Washington Public Power Supply System  
A JOINT OPERATING AGENCY

Docket Nos. 50-460  
50-513

Subject: WPPSS NUCLEAR PROJECTS NOS. 1 & 4  
PROPOSED PLANT DESIGN CHANGES

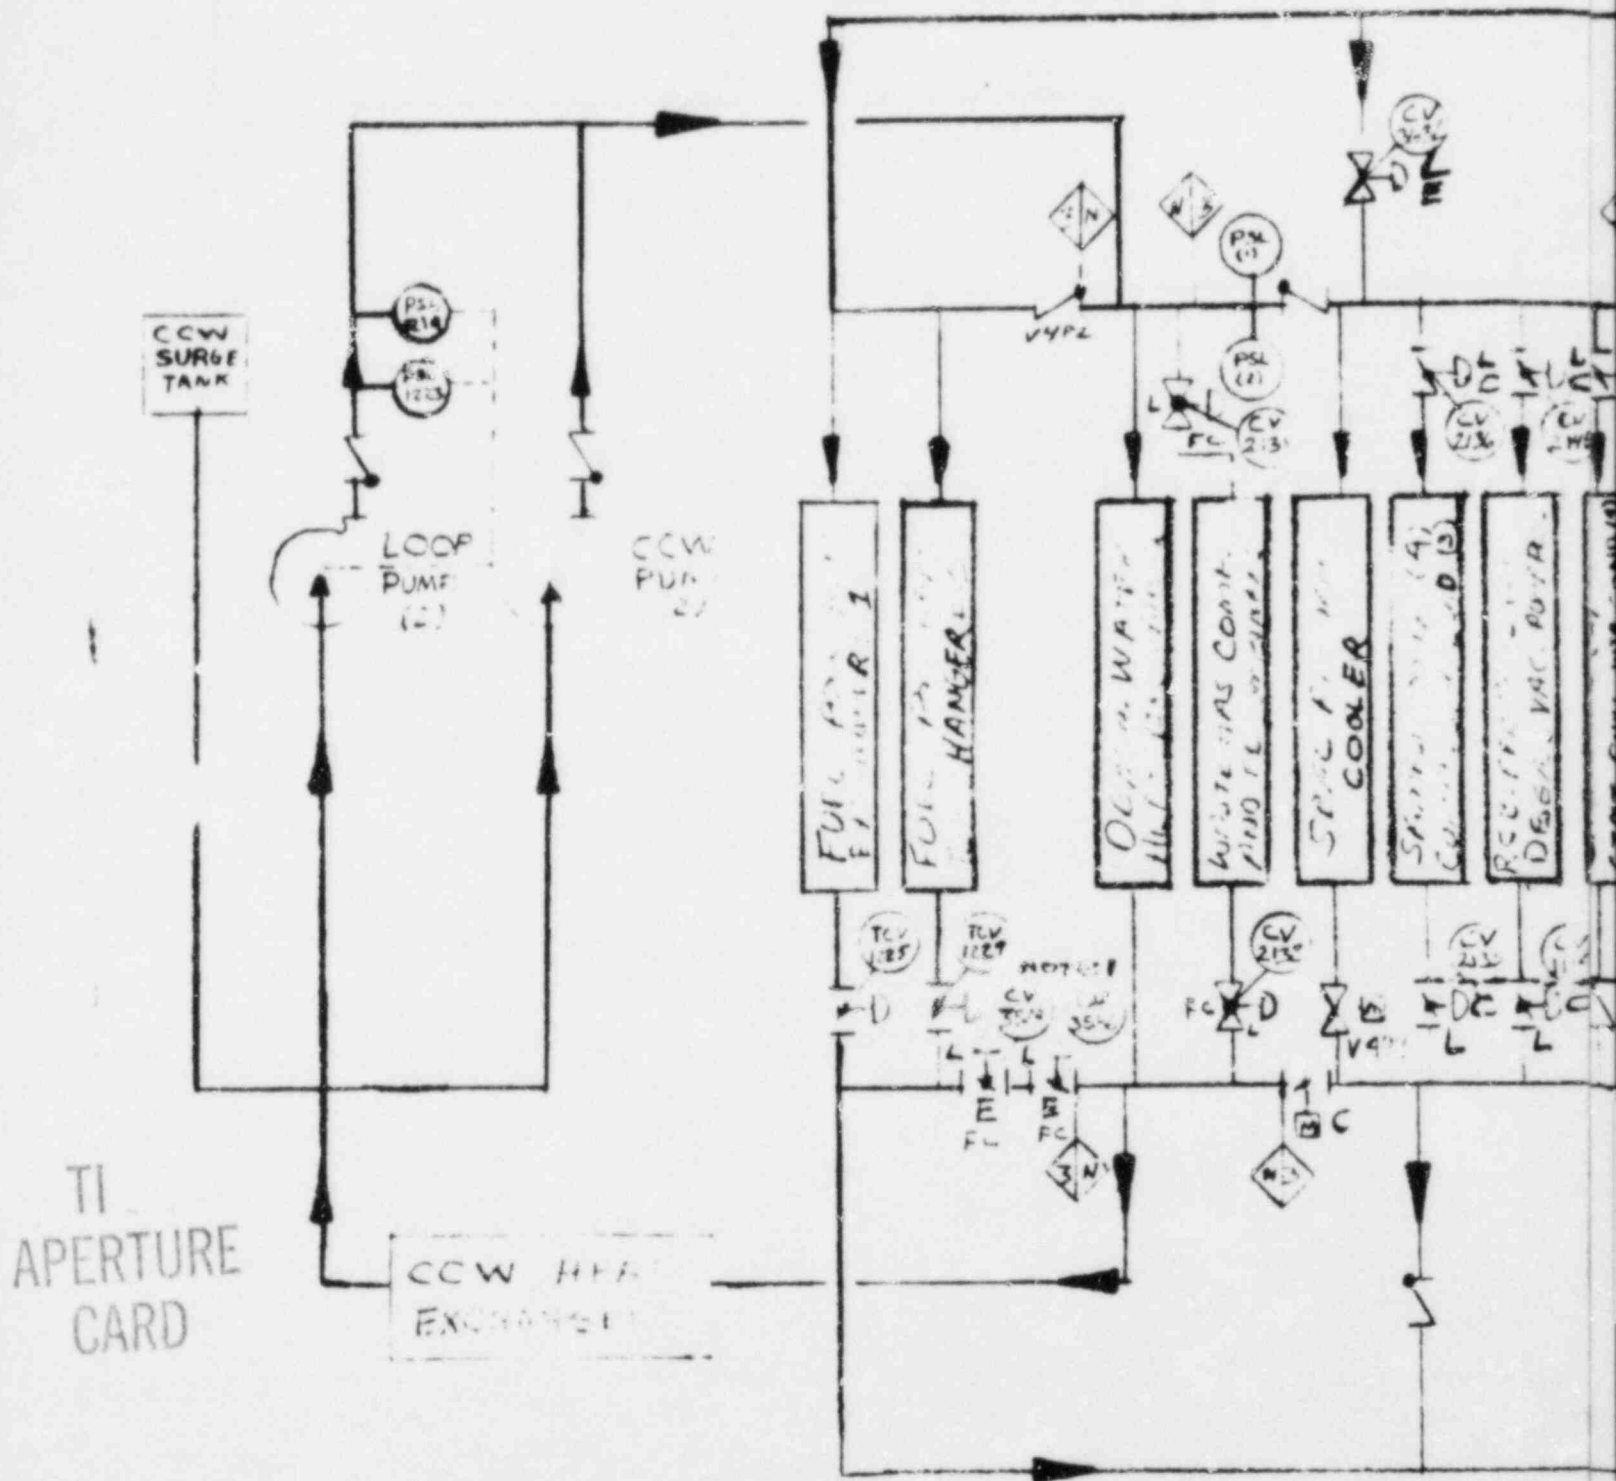
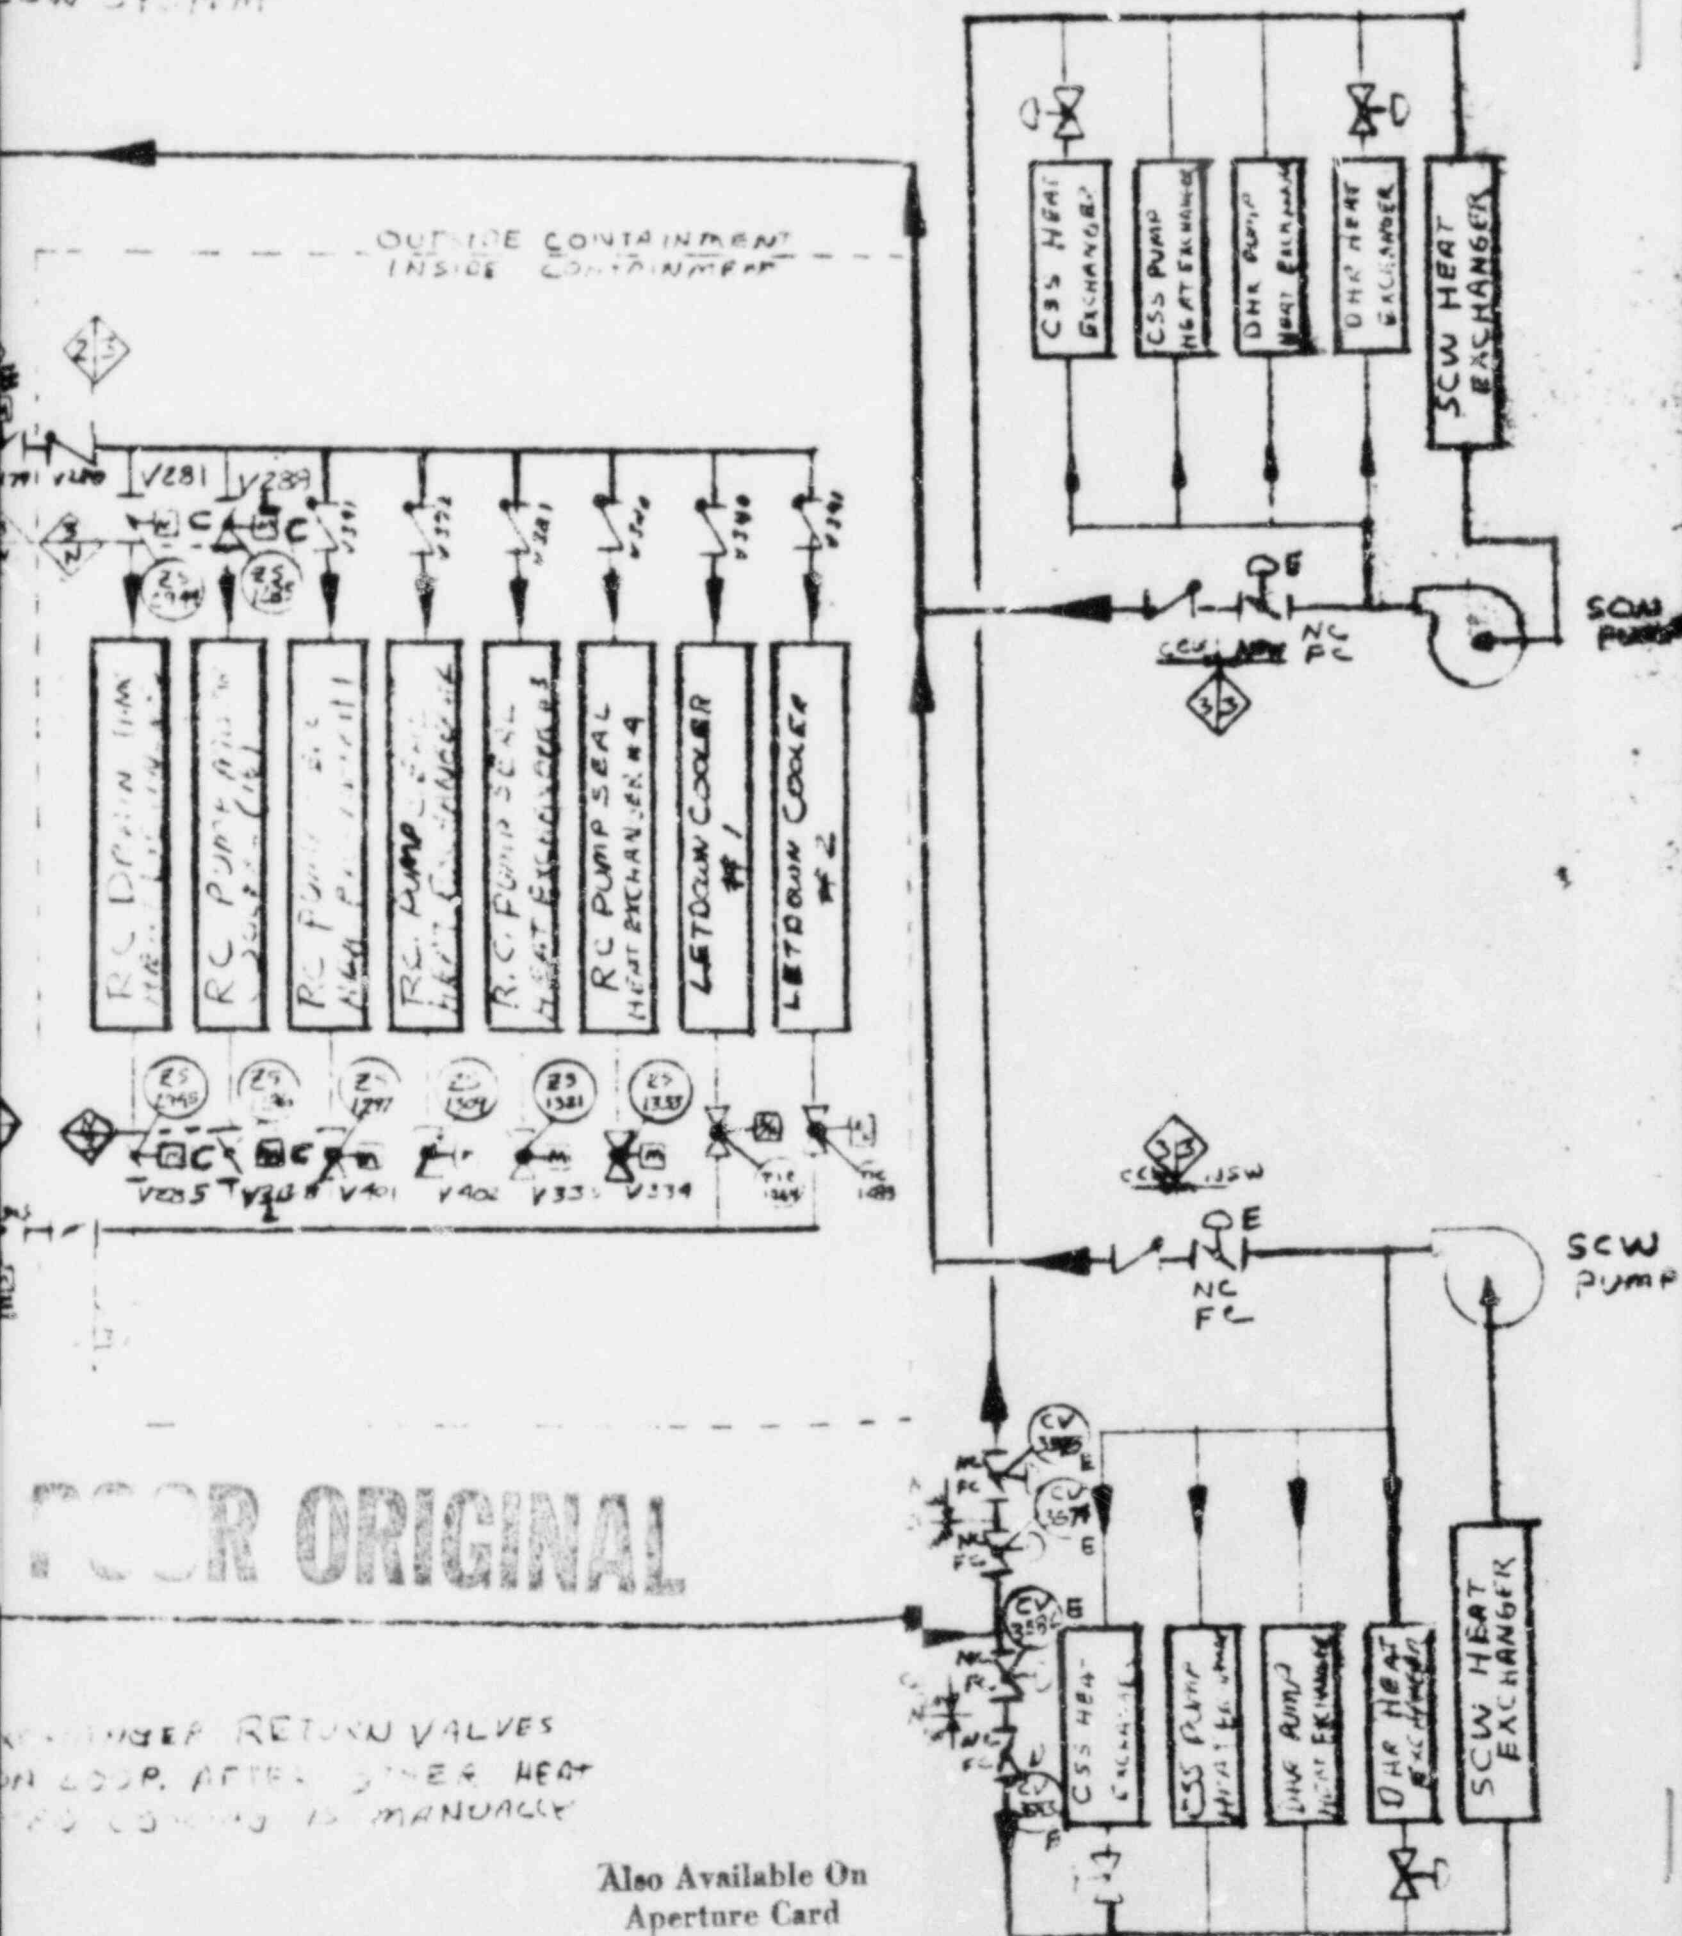
The Component Cooling Water (CCW) system as depicted in the PSAR provides ASME III, Class 3 and Seismic Category I piping to all components served by CCW regardless of the ANS safety class of the individual component. The CCW system will be re-designed to limit the ASME III, Class 3 piping only to those components important to plant safety as defined and required by Regulatory Guide 1.26 (Quality Group classifications for water-steam and radioactive waste containing components of nuclear power plants). The CCW system pumps, heat exchangers and the piping to and from components not important to plant safety are being re-designed in accordance with the requirements of Regulatory Guide 1.26, Quality Group D. Provisions are made in the system design to automatically isolate the safety related portions of the system from the non-safety related portions at the time a safety function is required. The automatic isolation provisions have been designed to be single-failure proof such that no single failure will prevent a safe shutdown of the plant. Cross-connects for the Nuclear Service Water (NSW) system are provided to assure cooling water to those components important to plant safety under all transients and conditions, such as SSE, LOOP, LOCA or any combination thereof.

Regulatory Guide 1.26 requires the primary and secondary cooling water systems associated with decay heat removal for the spent fuel storage facilities, as well as "cooling and seal water systems or portions of these systems and components important to safety such as reactor coolant pumps, diesels and control room" be designed to NRC Quality Group C (ASME III, Class 3, Seismic Category I) requirements. In addition, Regulatory Guide 1.29 requires these systems or portions of these systems be designed to withstand the effects of a SSE. Our interpretation of the above requirements is that, in addition to the components listed in Regulatory Guide 1.26 (spent fuel pool heat exchangers and the cooling water side of the RCP seal heat exchangers) the letdown coolers and the seal return coolers must also be supplied with ASME III, Class 3 and Seismic Category I cooling. However only the spent fuel pool heat exchangers require cooling during a LOCA and/or SSE. Under these conditions the CCW system will receive cooling water from one of the Shutdown Cooling Water (SCW) trains of the Nuclear Service Water System through ASME III, Class 3 and Seismic Category I cross-connects. The cross-connects are interlocked such that the cross-connect cannot be established unless the cross-connects to the other SCW train are closed and all NNS portions of the CCW system have been isolated. The attached figure is a functional flow diagram of the re-designed CCW system showing the cross-connects to the SCW system.

- 2 -  
not required will be isolated from the CCW system. Since each nonessential load has both an inlet and outlet automatic isolation valve, the failure of any one single valve to close will not prevent supplying required loads. The valves which automatically close are indicated on the attached drawing with "L" written next to the valve operator. The spent fuel pool heat exchanger does not require cooling immediately after a LOOP. When cooling water demand and heat loads from the other components have decreased, cooling water can be diverted to the spent fuel pool heat exchanger. This will be accomplished prior to the spent fuel pool temperature reaching 200°F (approximately seventeen hours).

Following a postulated SSE, cooling is required for the spent fuel pool heat exchangers only. If the CCW system remains functional, normal operation can continue, however, if the CCW pumps fail or if there is a rupture in the safety class NNS portion of the CCW system, the CCW/SCW cross-connect must be established. Since the spent fuel pool can be operated safely without cooling for approximately seventeen hours, the SCW/CCW cross-connect will not be automatically established. If the SSE causes a rupture in a non-nuclear portion of the CCW system, two Class 1E pressure monitoring systems will shut all the Class 3/Class N isolation valves. The operator must remote-manually open the SCW/CCW isolation valves. An interlock ensures that all non-nuclear safety portions of the CCW system have been isolated before the SCW/CCW isolation valves may be opened. Initially, cooling is supplied only to the spent fuel pool coolers; however, at the operators discretion the seal return coolers, RC pump seal heat exchangers and letdown coolers may be cooled by remote-manually opening CV-3632.

Following a LOCA, an ESFAS signal (mode 1) will automatically close the SCW/CCW cross connect isolation valves and the Containment isolation valves, CV-3632, CV-3588 and CV-3586. These valves are indicated on the attached drawing with an "E" next to the valve. The only components which require cooling are the spent fuel pool heat exchangers. The SCW/CCW cross-connect isolation valves must be remote-manually opened as described in SSE above.
